# ITEM #7 - PRELIMINARY PLAT MARVEL MANOR SUBDIVISION PHASE 6

KPB File No.	2024-035
Plat Committee Meeting:	May 13, 2024
Applicant / Owner:	Mark Hansen, Richland WA / Lori Stone, Sterling AK / Sue Moline, Stanley ND
Surveyor:	John Segesser / Segesser Surveys
General Location:	High Point Ave / Sterling

#### STAFF REPORT

Vicinity Map

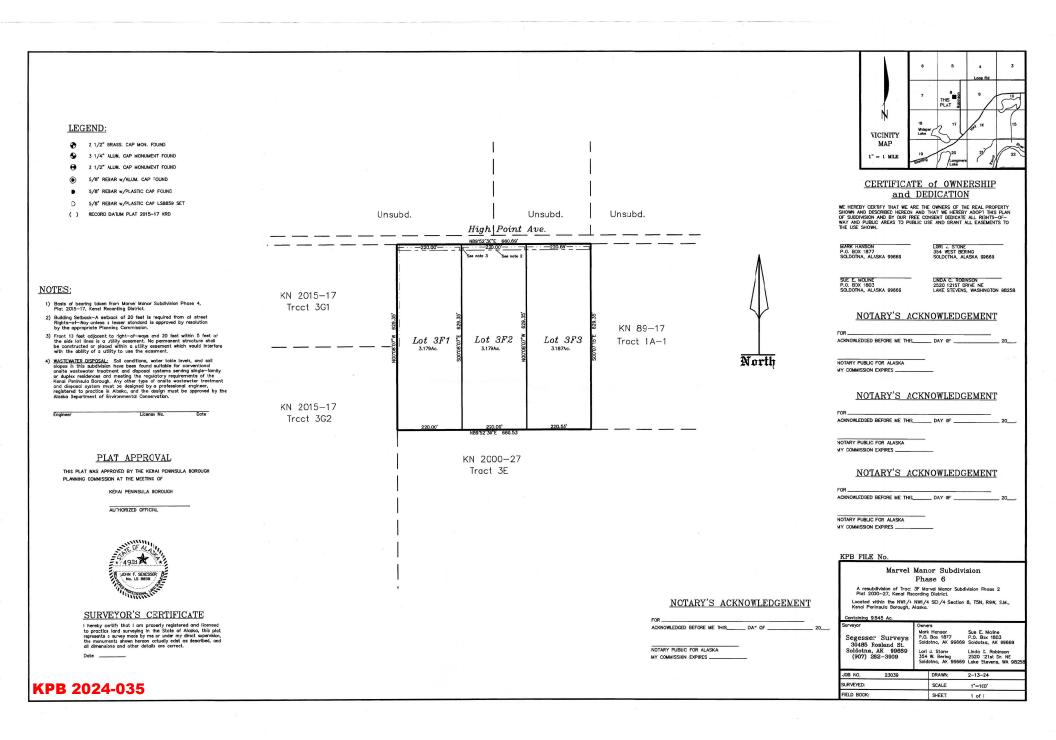
Add High Point Ave to vicinity map

label the lakes on the map
